Technical Service Information

TSI-03-13-05

Subject: Eaton Twin Countershaft Transmission Failures Caused by Incorrect Installation of Auxiliary Section

Topic: Proper Dowel Pin Location

Figure 1

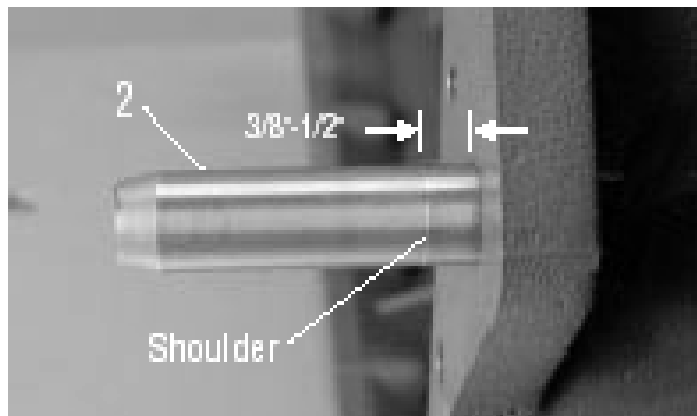
Transmission failures caused by incorrect auxiliary section installation. When installing the auxiliary section it is critical the dowel pins are in the proper location, failure to do so can cause various complaints including worn synchronizers, slow range/splitter shift and gear wear due to timing error.

The dowel pins must be properly installed prior to installing the auxiliary section. Please see Figure 1 for proper dowel pin installation. 3/8"-1/2" of pilot diameter must be exposed to rear of main case surface. Pilot diameter of dowel pin is .748" - .750".

Never tighten auxiliary section fasteners before installing dowel pins in proper location!
